Subject: AP1000 COL Standard Technical Report Submittal of APP-GW-GLN-019, Revision 2 (TR 103)

The changes within this Technical Report are a compilation of approved design changes to AP1000 Fluid Systems that have not previously been submitted under individual header. This document is sectioned to identify Fluid System changes that have been approved by the Westinghouse Change Control Board, that have not been submitted in previous Technical Reports, and that have had a direct impact on the Design Control Document (DCD). These are predominantly minor changes in system designs that are due to the progression of the detailed design. Each change will be individually identified within this document. The description of these changes can be found within Section II of this document. Additionally, not all of the changes described within this document have been incorporated into Rev. 16 of the AP1000 Design Control Document. The changes to R16 are detailed on pages 144 to 149.

Title: Fluid System Changes

Figure 9.3.6-1 (Sheet 2 of 2)
 Batching Tank Heater Control

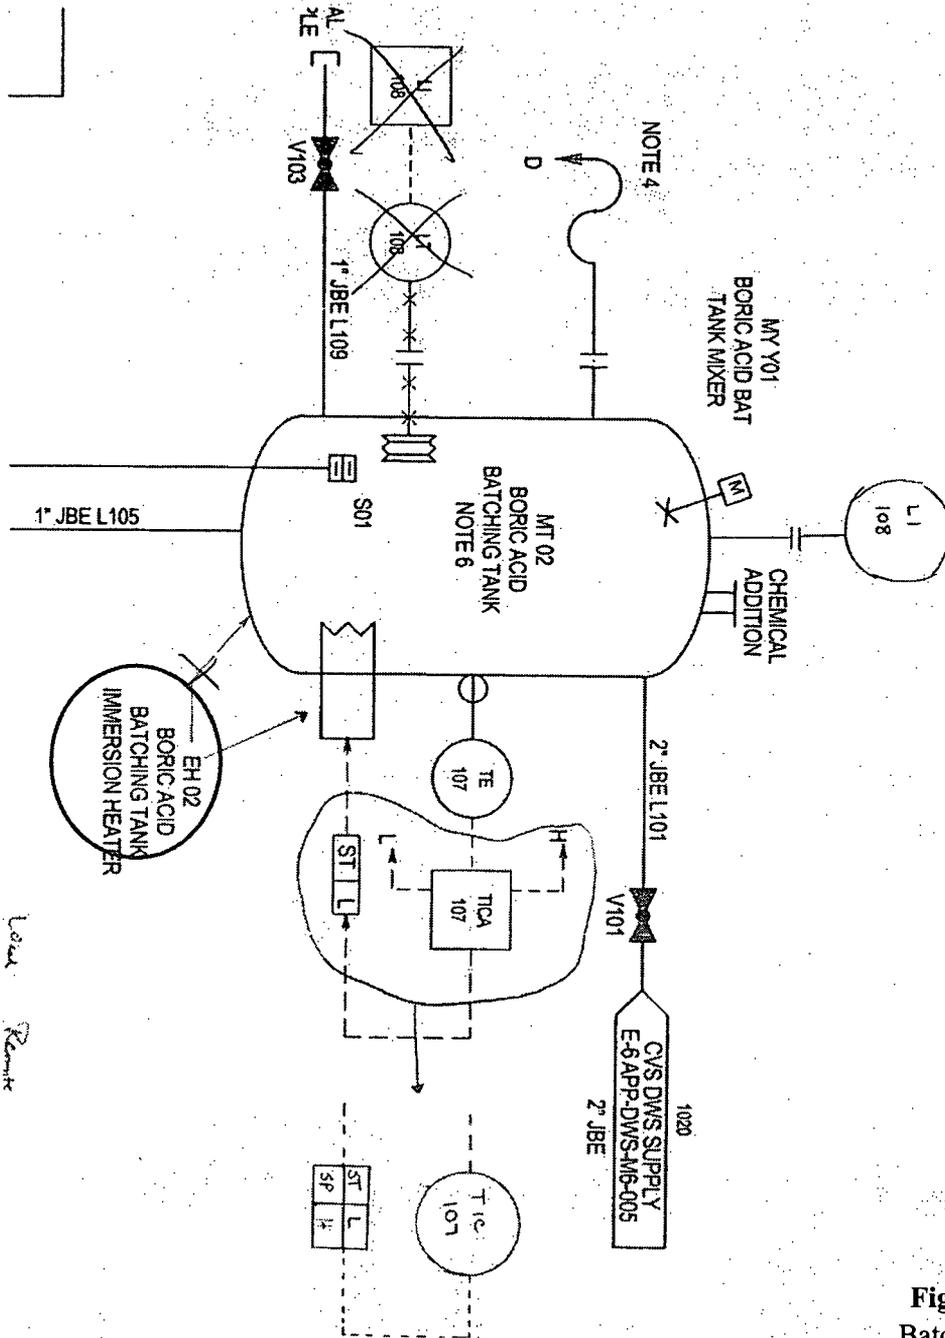
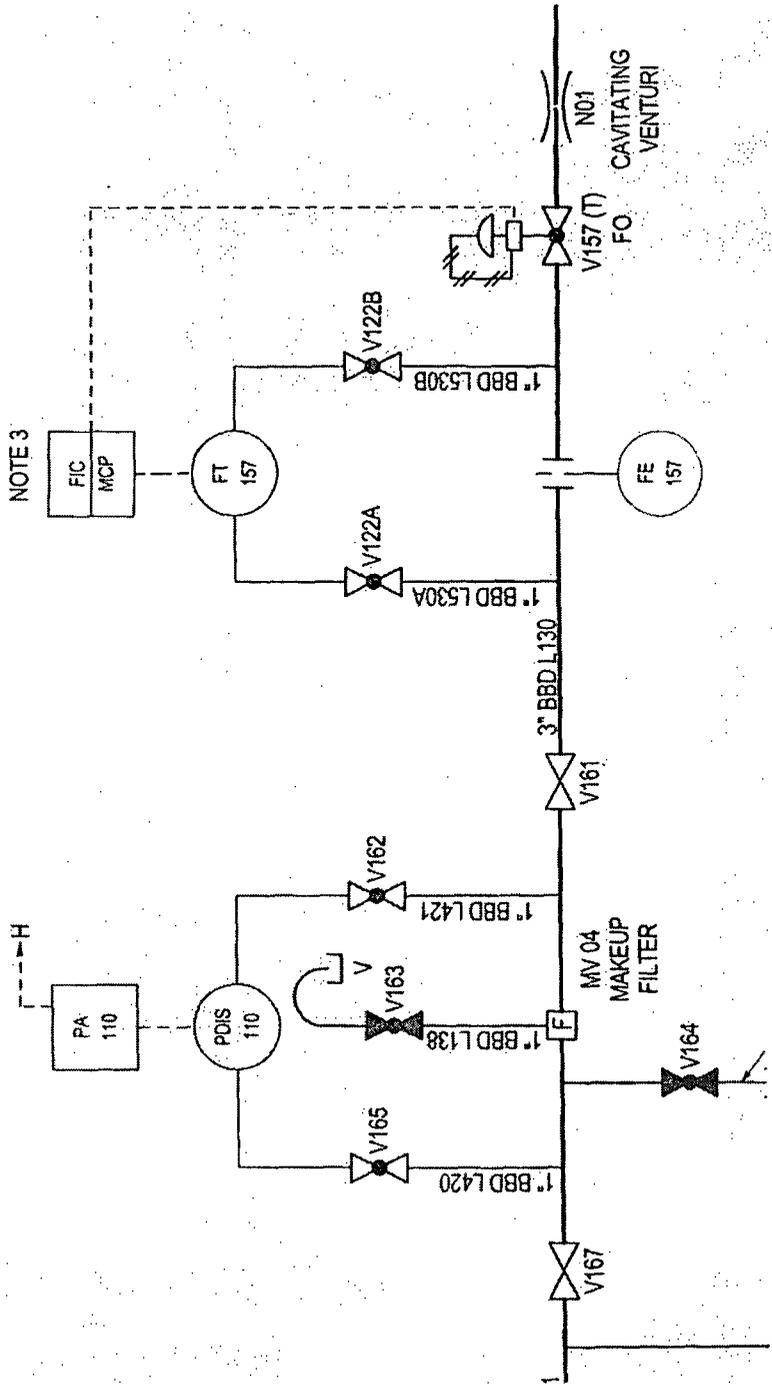
The interlock between valves CVS-PL-V001, 002, 003 and temperature instrument TICA-002 has been revised because having three interlocks increases the potential for inadvertent actuation of system isolation which would result in thermal transient to the CVS heat exchangers, which should be avoided. The present DCD figure shows an interlock between TICA-002 and three purification isolation valves, CVS-PL-V001, V002 and V003 which is used to protect the demineralizer resin beds from excessive temperature. A single MOV closure is sufficient for automatic CVS isolation, and therefore, the interlocks between TICA-002 and CVS-PL-V001 and V002 are deleted as marked on the schematic drawing in Section III. A high alarm and signal to CCS-PL-V221 and a high interlock between CVS-PL-V003 and TICA-002 are sufficient to protect the demineralizer resin beds from overheating.

A standard heating unit for the immersion heaters in tanks has been selected. Depending upon the connection of the heating element, the unit is able to produce either 13.3 kw or 4.43 kw. For extreme weather conditions it has been determined that the Boric Acid Tank will require 16.6 kw of heat to prevent freezing; therefore, two standard heating elements are required. Each heating element will have its own immersion well in the tank, and each will be configured differently. The CVS figure in Tier 2 has been updated to show two heating elements.

During the operation of the boric acid batching tank, there is no need for control room personnel to monitor or control any aspect of the tank operation. An operator locally controls all aspects; therefore, local indication and control of temperature and level is now specified with no remote operation or indication. DCD Figure 9.3.6 has been updated to show this change.

Valve V059 receives a PLS signal on low level during mid-loop operations via the PMS concurrent with valves V045 and V047. Therefore, a note has been added to the CIB, Note 23 "PLS – Closes CVS-V059 to Isolate Letdown on Low Hot Leg Level During Midloop." Updates are shown on DCD Figure 9.3.6.

Figure 9.4.1-1 (Sheet 4 of 7)
 Nuclear Island Non-Radioactive Ventilation System
 Piping and Instrumentation Diagram
 (REF) VBS 004

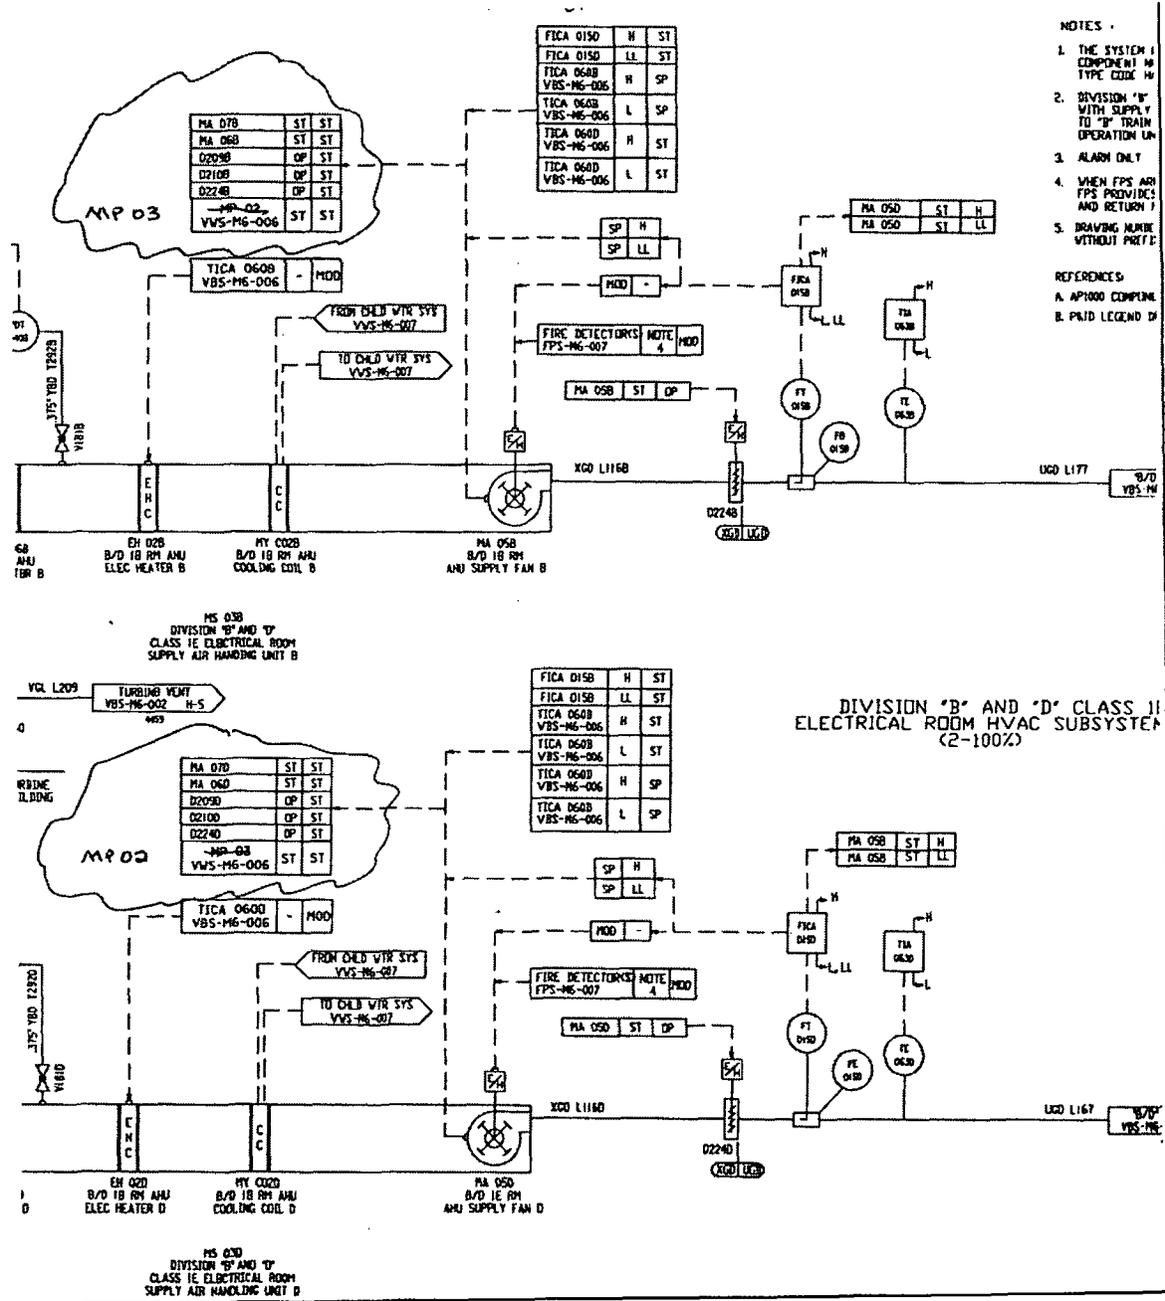
The control logic depicted on the VBS Figure 9.4.1-1 (Sheet 4 of 7) of the DCD for the VBS fans serving the Class 1E Division B & D Electrical Rooms has been changed so that starting an air handling unit will start the chilled water system associated with that air handling unit. Previously, starting air handling unit MS03B sent a signal to the VWS to start chilled water pump MP02, which provides chilled water to air handling unit MS03D. In the same manner, starting air handling unit MS03D sent a signal to the VWS to start chilled water pump MP03, which provides chilled water to air handling unit MS03B. In both cases, starting the air handling unit fails to start the correct water chiller, and therefore the cooling system would not have operated correctly. The logic has been corrected so that starting air handling unit MS03B will start chilled water pump MP03 and starting air handling unit MS03D will start chilled water pump MP02; thus, starting each air handling unit will start the respective supporting pump.

Figure 10.4.7-1 (Sheet 4 of 4)
Condensate and Feedwater System
Piping and Instrumental Diagram

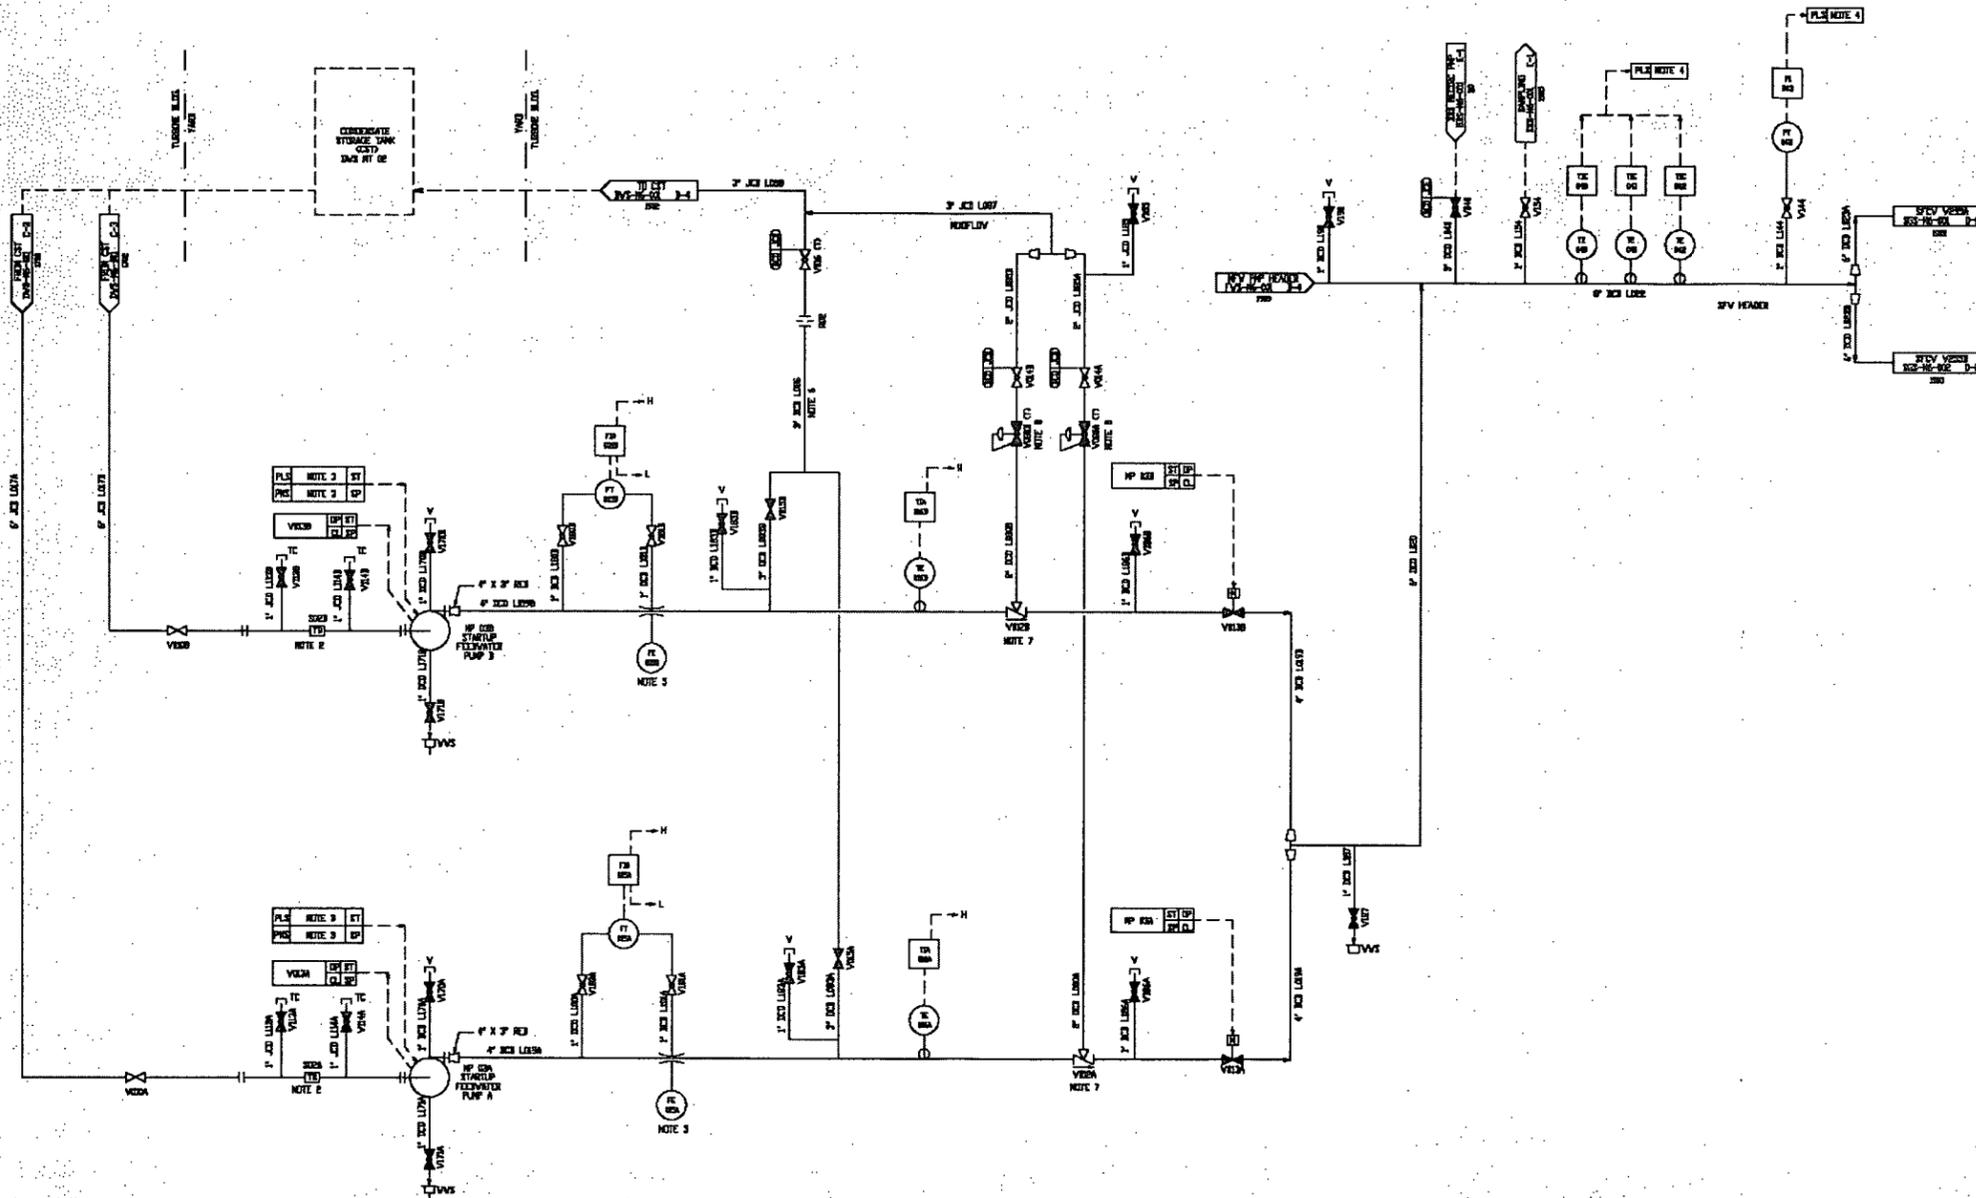
It was necessary to eliminate the control function shown on the Startup Feedwater DCD Figure 10.4.7-1 (Sheet 4 of 4), and in DCD section 7.7.1.8.2 for pressure transmitters PT 043-45 because the startup feedwater header pressure is no longer an input to the Startup Feedwater control System. Additionally, the Main Feedwater System also no longer utilizes the main feedwater header pressure or pressure drop across the main feedwater control valve as an input to its control system. Therefore, section 7.7.1.8.1 of the DCD has been revised.

All three pressure transmitters are no longer necessary since they do not have a control function. Pressure transmitters 044 and 045 have been deleted. Additionally, Note 4 has been revised to reflect the updated control logic diagram APP-PLS-J1-143, and the statement in the note that mentions startup feedwater header pressure as an input to the control system has been deleted. A change in has also been made in Note 3 to indicate that control logic diagram PLS-J1-114 has been updated and is now APP-PLS-J1-144.

Figure 11.3-1
Gaseous Radwaste System
Piping and Instrumentation Diagram

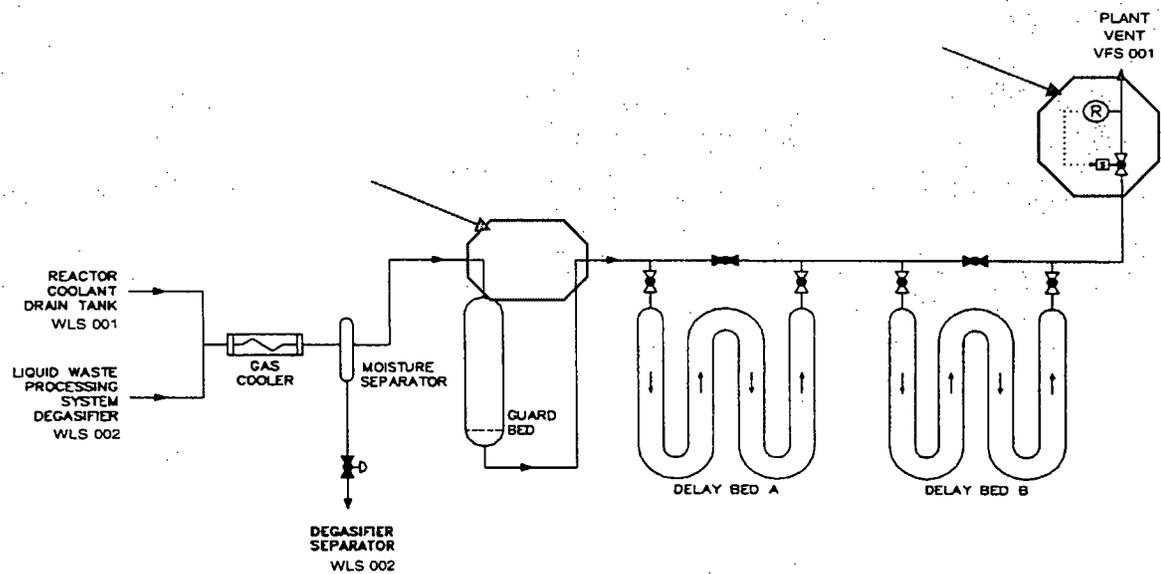
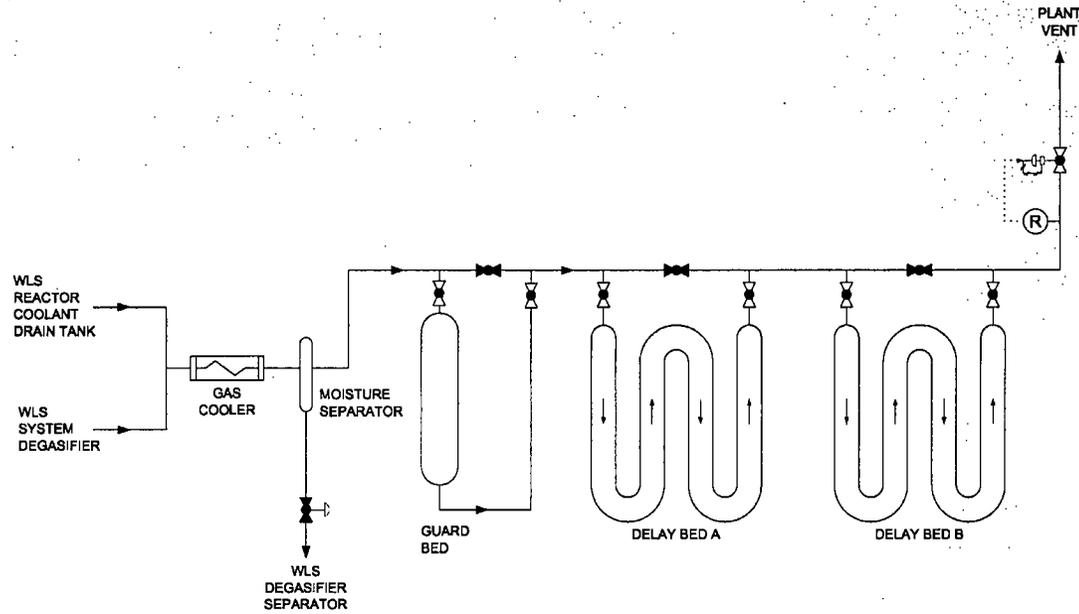
The previous version of the Gaseous Radwaste System (WGS) simplified sketch shown in the DCD did not accurately depict the current status of the WGS design. The sketch has been updated to reflect the current AP1000 WGS design by correcting the valve type for the discharge valve and the moisture separator drain valve, as well as moving the discharge radiation monitor upstream of the discharge valve. The change in valve type is for standardization and does not affect the system function. The relocation of the radiation monitor will allow for isolation of the system with minimal gaseous releases with above acceptable radiation levels.

Figure 6.4-2
Piping and Instrumentation Diagram Main Control Room
Emergency Habitability System

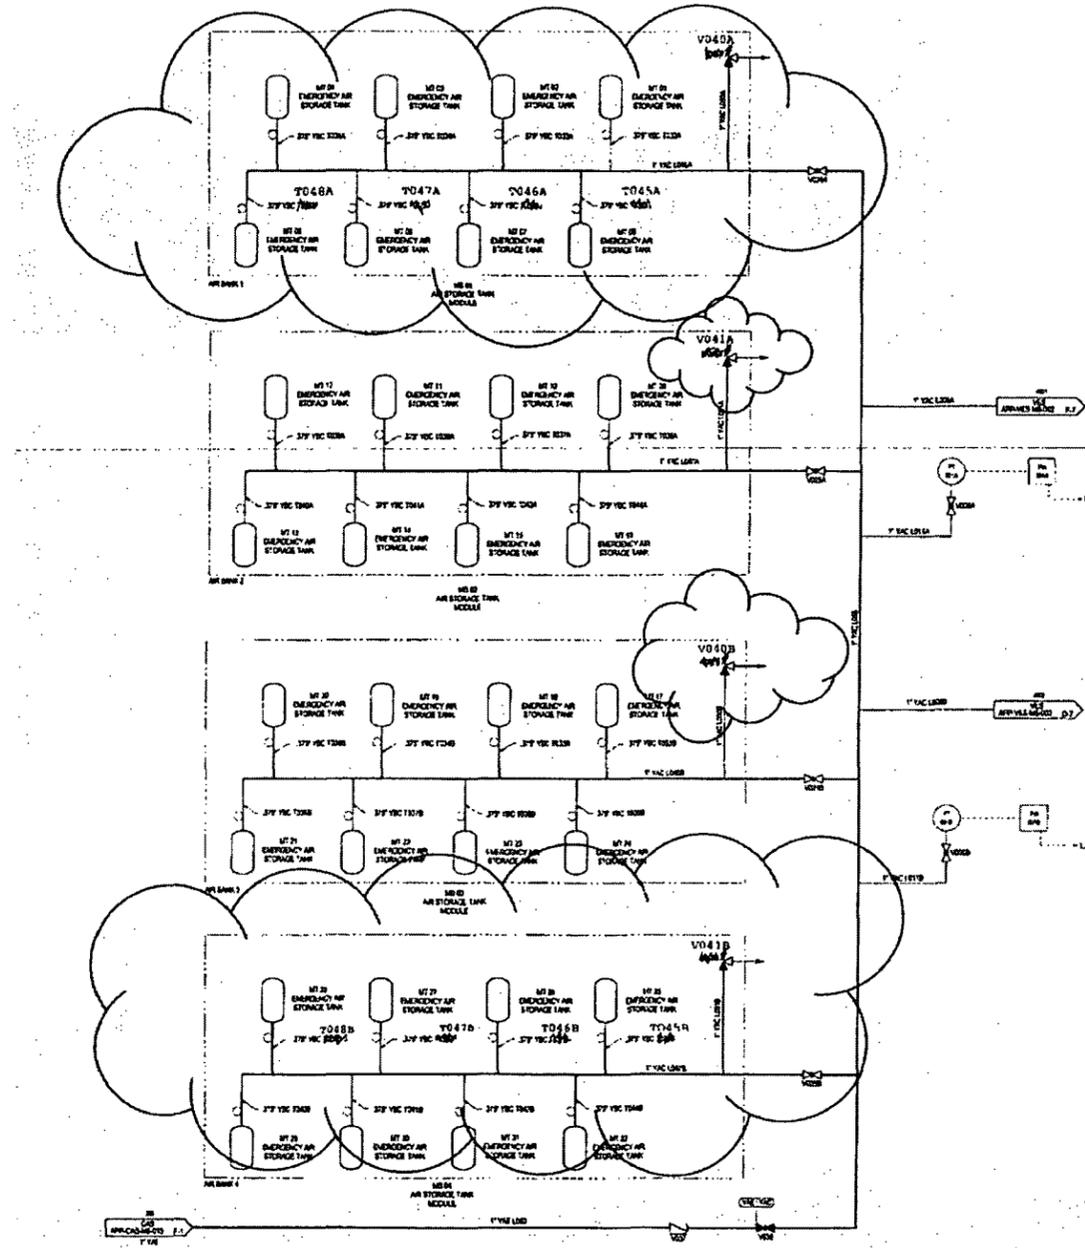
AP1000 Control Room Emergency Habitability System (VES) DCD Figures have been updated to correct line and valve number duplications and inconsistencies present in the current version of the diagrams. The description of the AP1000 VES in the Tier 2 section of the AP1000 DCD includes Figure 6.4-2. The markup is shown in Section III of this document.
